Miki Block Subdivision

Coventry, Connecticut

REPORT

Review Date: JANUARY 7, 1986

SUBDIVISION PLAN FOR MIKI BLOCK

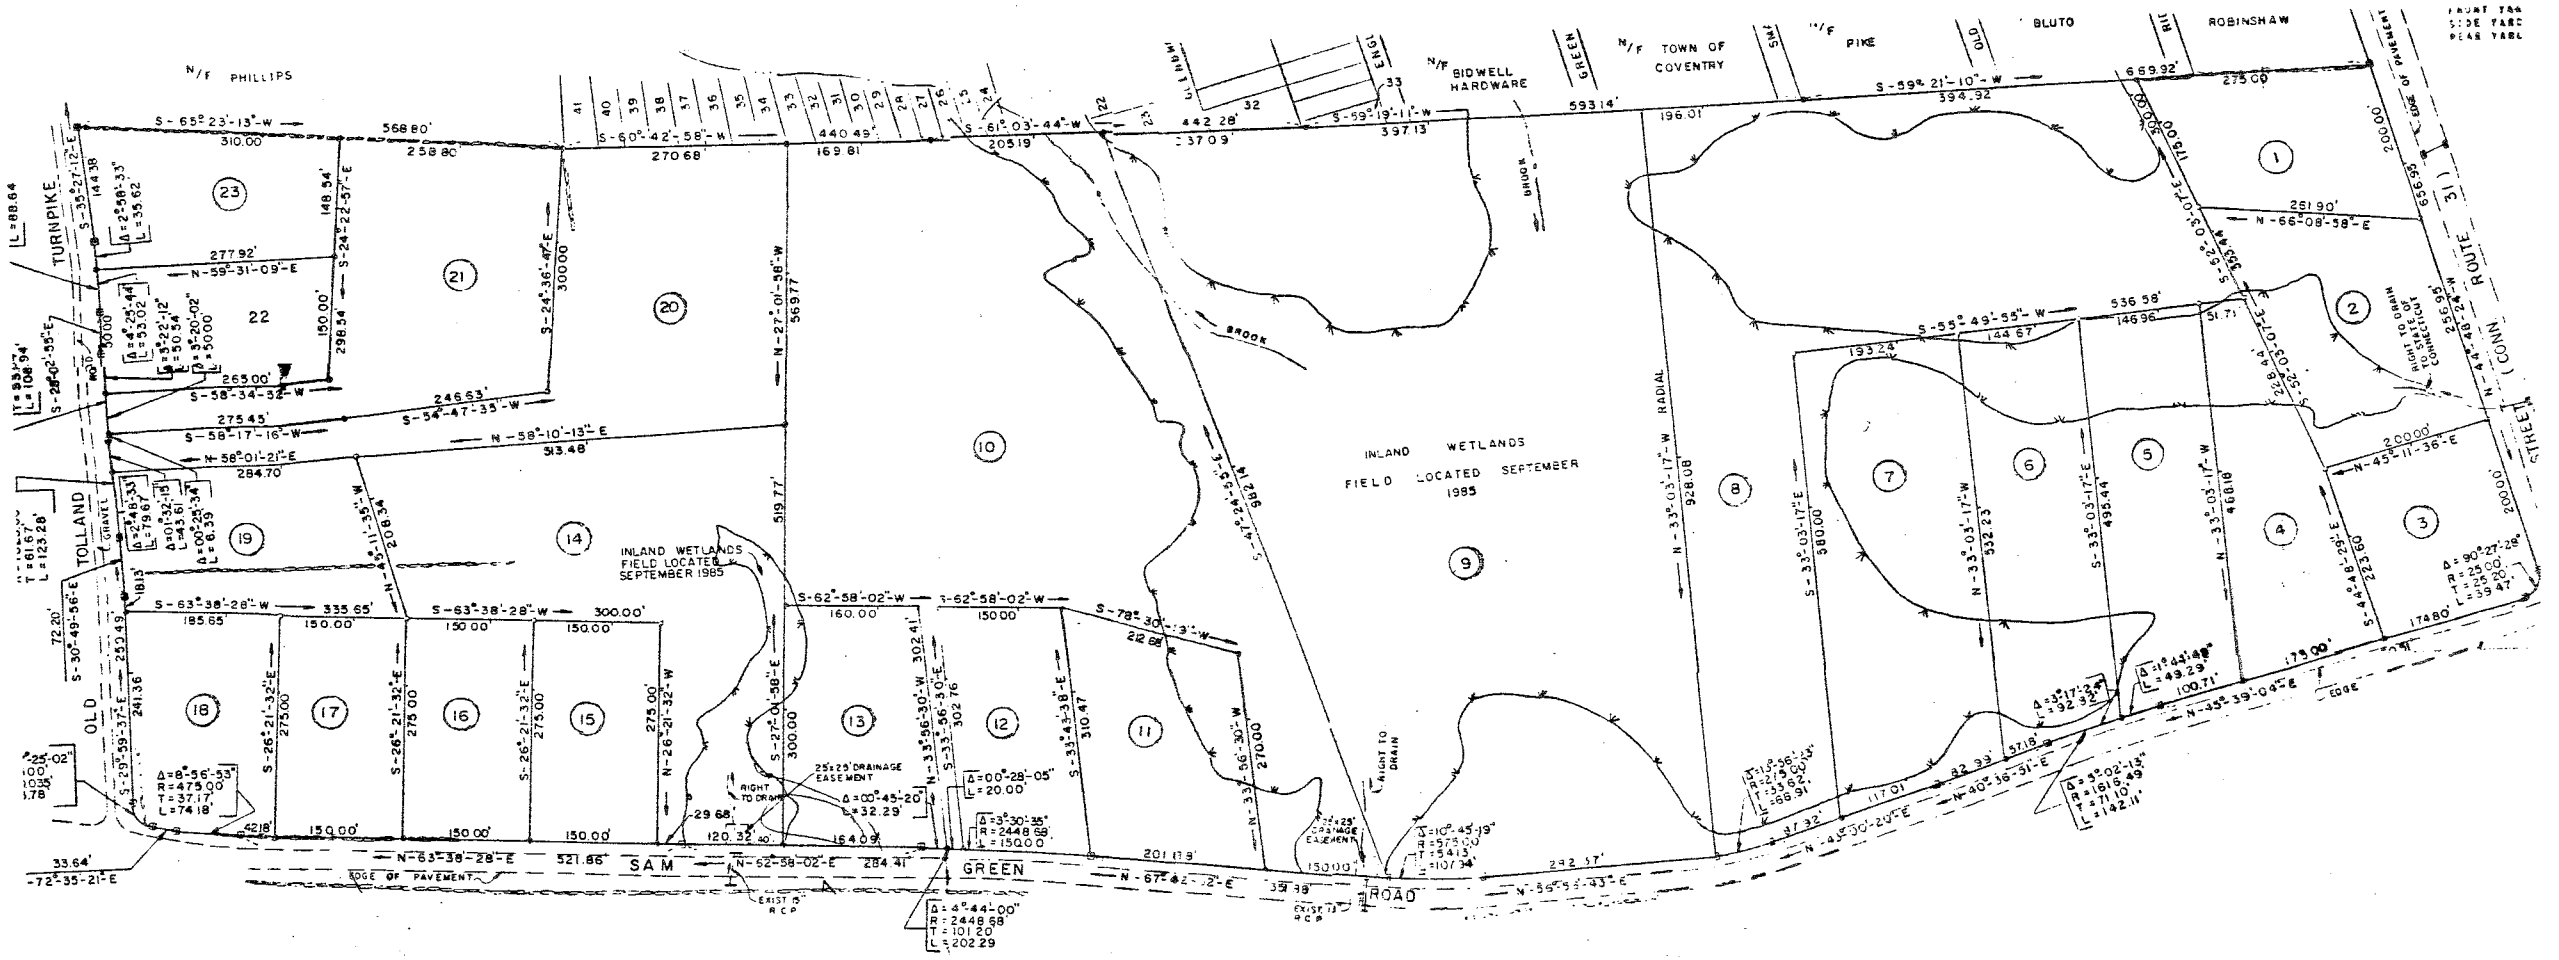
The Team's Geologist has reservations with regard to the present layout of septic systems and house locations serving lots 1 and 2. Present plans show septic systems located in the front part of the lots at a higher elevation than the proposed house. On-site wells, which are not indicated on the plans, would need to be located to the rear of the property in order to meet Public Health Code separating distances. (As noted earlier, proposed well locations should be shown on the final subdivision plans.) Best planning practices would be to locate a well upgradient from a septic system(s). In this particular area (lots 1 and 2), it seems likely that a better arrangement would be to locate the house closer to the road, at a higher elevation on the lot, and to locate the leaching system (primary and reserve areas) off to the side of the house, and properly locate the well on the opposite side of the lot. Using this arrangement, the well, septic system and house could take advantage of higher ground and ultimately better subsurface conditions. However, it appears

that in order to use this arrangement, lots 1 and 2 would have to be combined, particularly in view of the Town's 75 foot separating distance requirement from inland-wetland areas, as well as other required Public Health Code separating distances. Also, based on visual observations, it appears that development of lot 9 (the front portion along Sam Green Road) will be difficult due to the presence of inland-setland soils, which require a 75 foot setback. This will significantly limit the suitable area for development, i.e., house, well, and septic system on this lot.

Town officials on the review day expressed concern with regard to inland-wetland crossings. Based on the subdivision plan submitted to team members on the review day, access drives on at least two lots (depending on desired house location) will need to cross regulated inland-wetland soils. It should be noted that the project engineer indicated on the review day that access to lots 8 and 9, both of which contain substantial wetlands, might be accomplished by town roads, i.e., Glenbrook Trail, Englewood Trail, Smallwood Trail and Old Oak Trail from the east. The exact inland-wetland boundaries on the properties each of the subdivision plan were not made available to team members on the review day. Depending on these boundaries, access to lots 8 and 9 might be

more desirable from the east, thereby causing less or no disturbance to wetlands. Although undesirable, wetland road crossings are feasible provided they are properly engineered. The road should be constructed adequately above the surface elevation of the wetlands. This will allow for better drainage of the road and also decrease the frost heaving potential of the road. Road construction through wetlands should preferably be done during the dry time of the year, and should include provisions for effective erosion and sediment control. Finally, culvert(s) should be properly sized and located so as not to alter the water levels in the wetland or cause flooding problems.

In general, it would seem that some modification or reduction of lots in the front portion (Route 31 area) of the subdivision would be desirable given limited area and restrictive site factors.

Alternate lot layouts should be considered to minimize the need to fill wetland areas for driveways.

The town encourages shared driveways to minimize curb cuts on road frontages. Shared drives are a good idea but in practice problems sometimes arise. The parties sharing the driveway sometimes fail to agree on use, maintenance, or repair needs and costs. On occasion, such disagreements lead to each party wishing to construct their own drives on their own property. The Coventry Planning and Zoning Commission should keep these issues in mind when approving shared drives. Where possible an alternate, unobstructed, driveway location should be available to each lot owner on their own lot. Where extensive wetland crossings would be required, alternate lot layouts should be considered. Lot #8 is an example of such an issue.

Well locations should be shown on the plan. While not required by law, each well and 75' setback should fall within each lot's area and not include land in adjacent lots for good planning practice.

Sam Green Road curves along the proposed subdivision in the area of lot #9. The Planning and Zoning Commission should consider the need for road straightening and acquire right of way, if needed, in conjunction with the subdivision approval. Route 31 in this area carries an average of 6,500 vehicles per day in both directions (ConnDOT 1983 count). No accidents were reported on Route 31 at the intersection of Sam Green Road between 1981 and 1984.

Lot No. 9 does not appear to have an adequate site line for a driveway cut. The Planning and Zoning Commission should consider the need for road straightening in the area of lot No. 9.

WATERSHED BOUNDARY

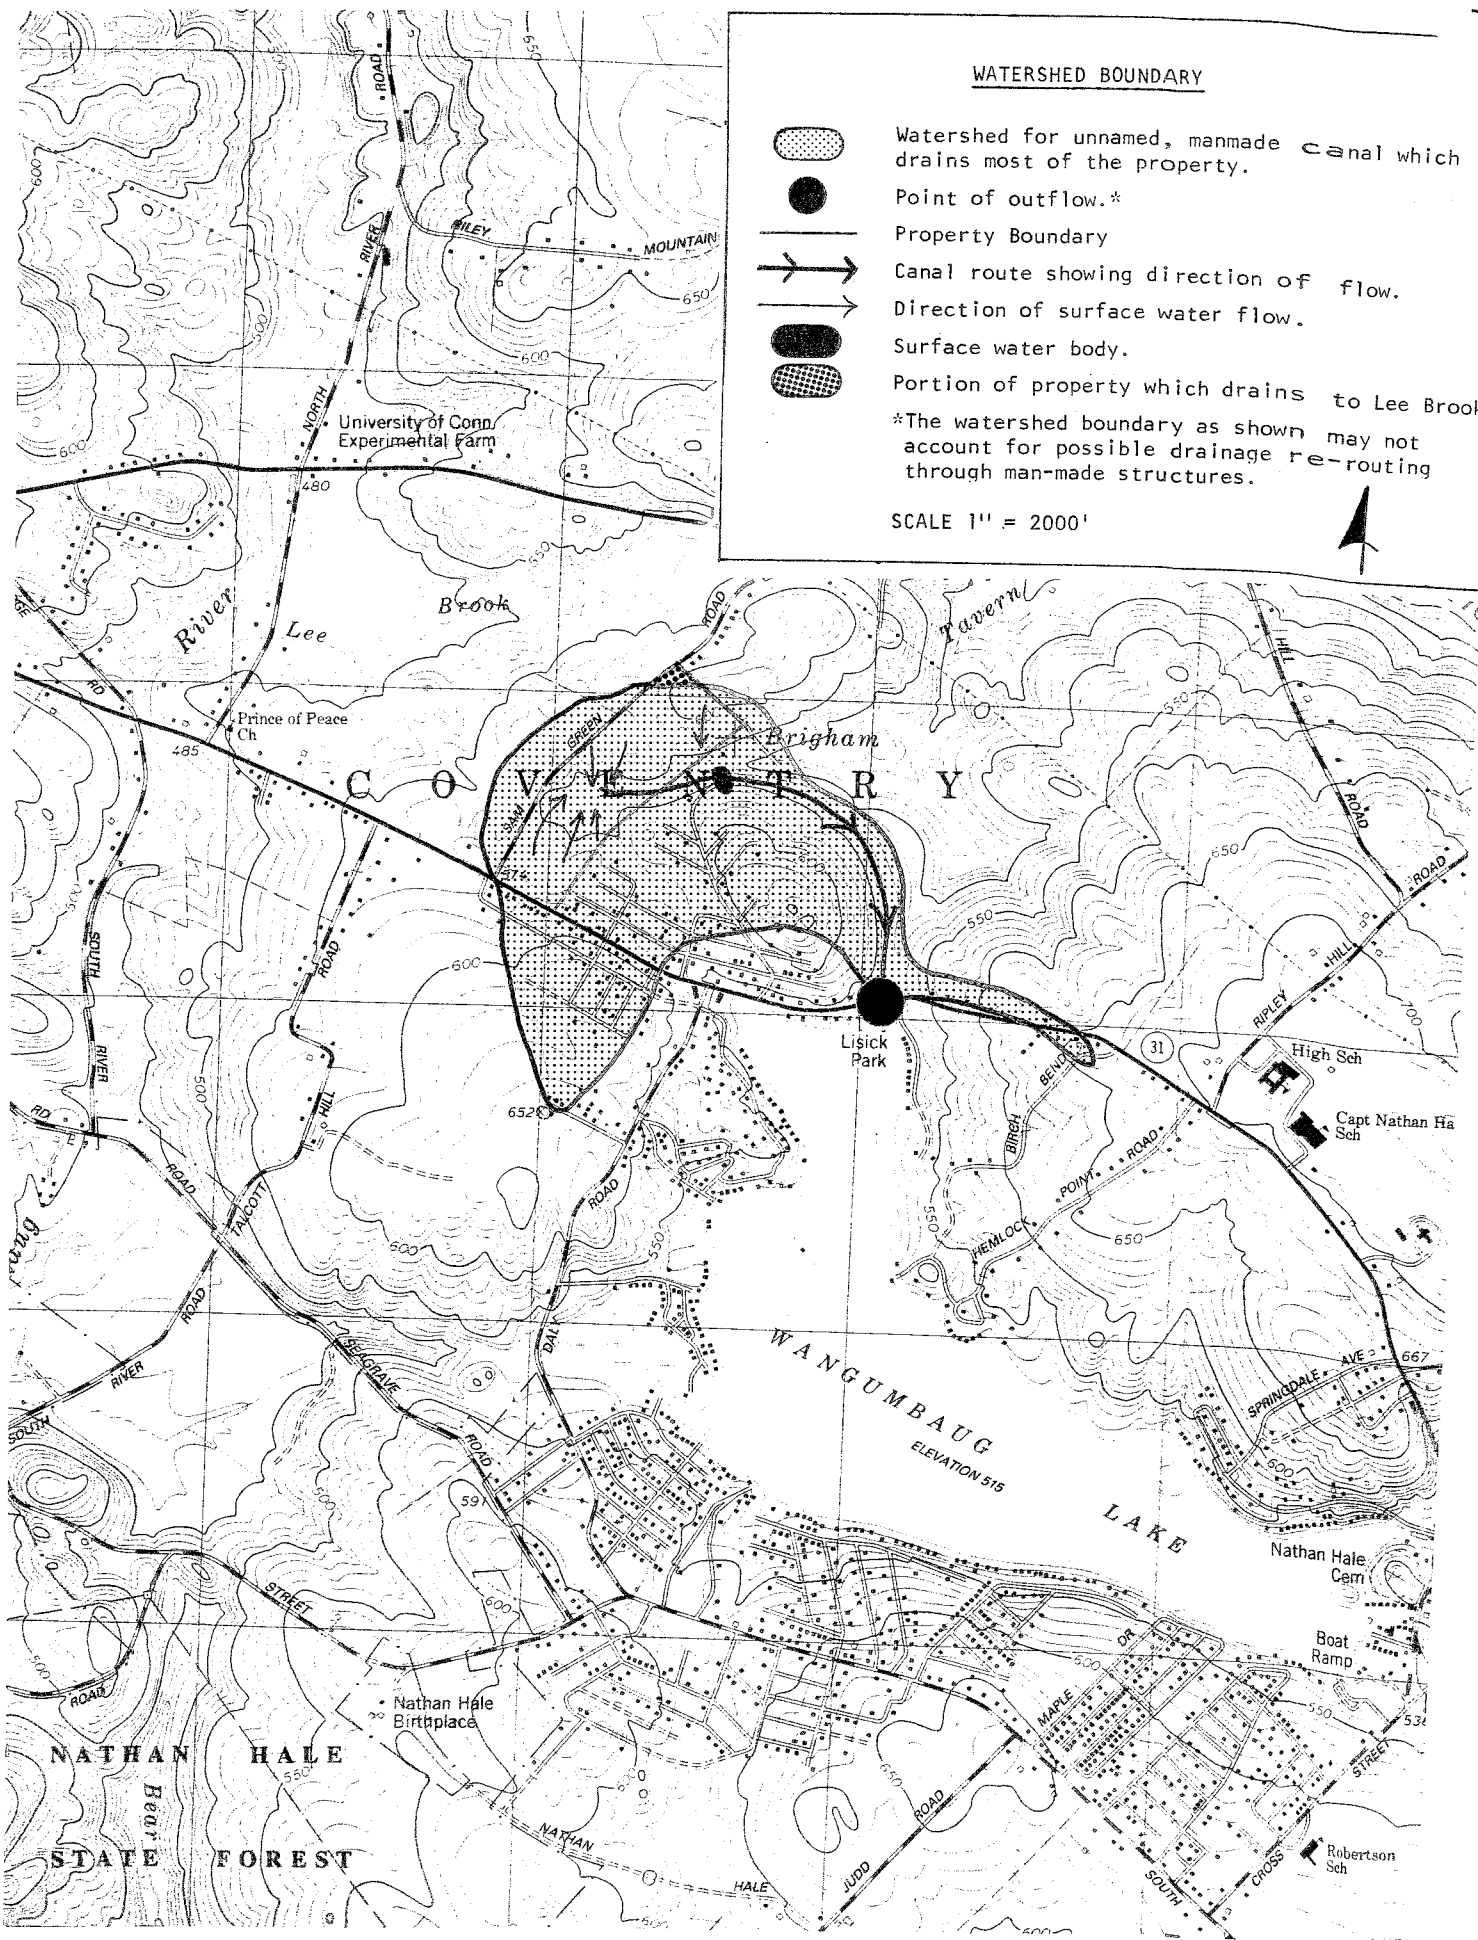
Nearly all of the surface drainage on the site flows downslope to either the wetlands in the central parts, or to the outlet stream for the wetlands. This stream empties into a small pond just east of the site. There are two outlets for this pond. Some of the water flows eastward and forms the headwaters of Bingham Tavern Brook, a tributary to the Willimantic River. The other outlet consists of a man-made canal which routes the water directly to Coventry Lake. It should be pointed out that the canal has been obstructed between the Pond and the Lake. Surface runoff from a very small, northwest corner of the subdivision site appears to flow northward to Lee Brook, which is a tributary to Skungamaug River.

The subdivision of the property as planned, followed by the construction of new homes, driveways, interior road systems, etc., will lead to some increases in runoff from the property. Ordinarily, the Team geologist would recommend that consideration be given to measures that would mitigate the effects of these increases (e.g., a stormwater detention basin).

In this case, however, the relatively large flat wetland area in the central parts should help detain any increased runoff from the development. In addition, the small pond to the east, which will also ultimately receive drainage from the site, will serve as a natural runoff control basin. Under these circumstances, runoff retention does not seem to be necessary. However, if the Town has an ordinance which requires no increases in the amount of runoff shed from a particular site following development, then the project engineer will need to address this possible concern.

PROPOSED SUBDIVISION
COVENTRY

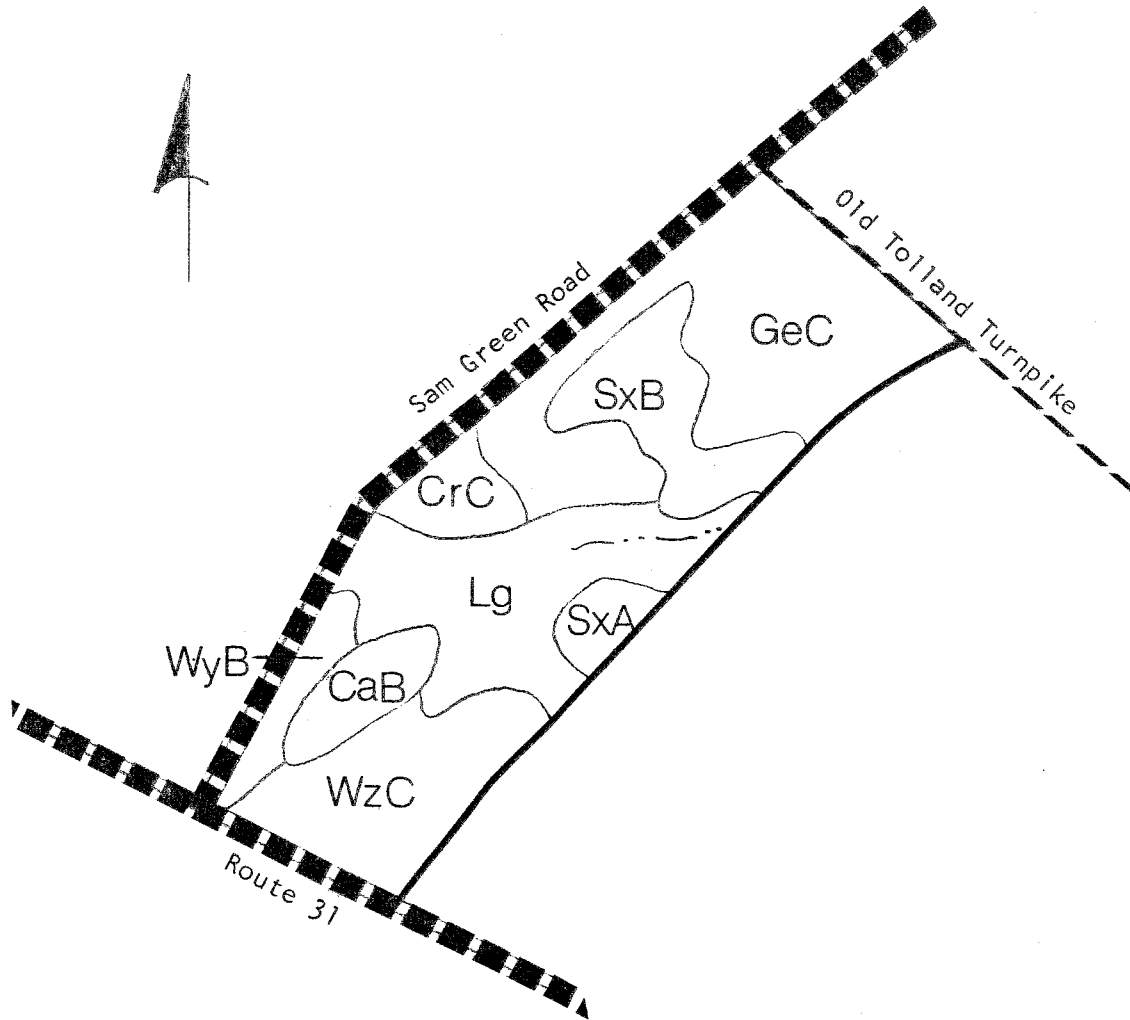
Overlying the till in the central parts is an east-west trending band of seasonally wet soils. They occupy the low-lying areas on the site. This area is delineated on the accompanying soils map as Lg, and are classified as inland-wetland soils in Connecticut. As a result, they are regulated under Public Act 155. Any activity which involves modification, filling, removal of soils, etc., will require a permit and ultimate approval by the Town's Inland-Wetland Commission. This wetland area has at least some ability to reduce runoff and control water quality. For this reason, it is recommended that inland-wetland soils on the site not be disturbed.

The high water table and slow to very slow permeability are major limitations of the soils of this unit for community development. Steep slopes of excavations in these soils slump when saturated. The stones on the surface restrict landscaping, and lawns are soggy most of the year.
